HL roof drains & safety roof drains

Change to the tightening torque specification for stainless steel clamping flanges

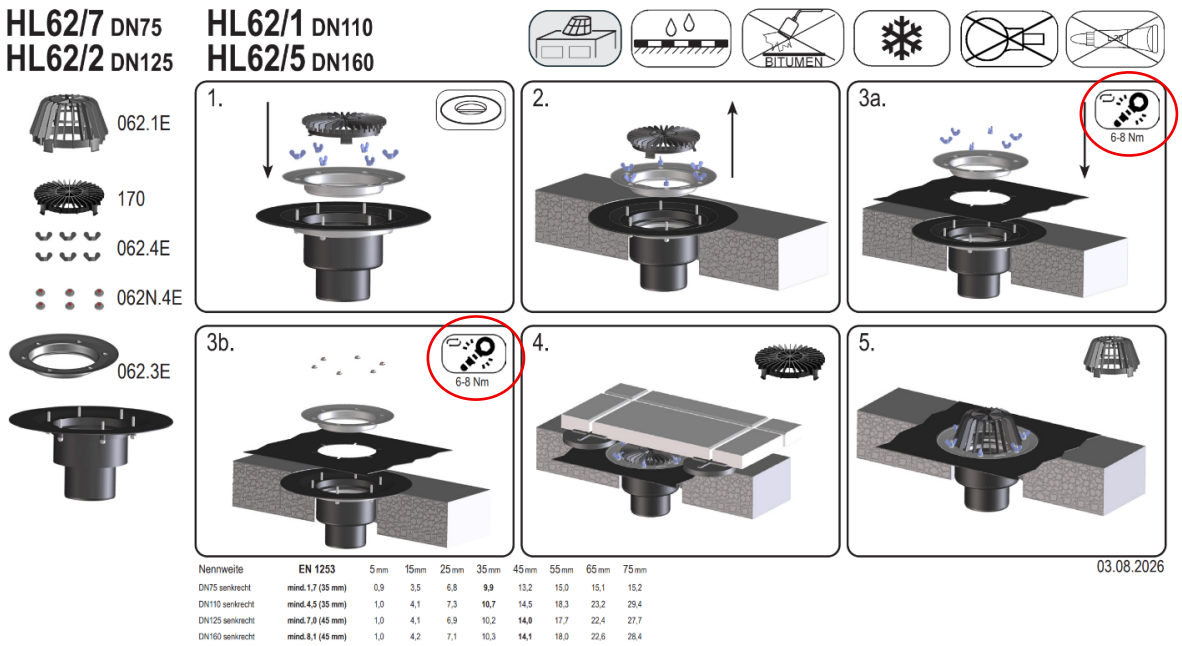
The previous maximum tightening torque specification of 13 Nm has been replaced by a torque range of 6–8 Nm. This adjustment provides a more precise specification for correct installation of the stainless steel clamping flange.

An example of the updated specification in the instruction leaflet is shown in the image below.
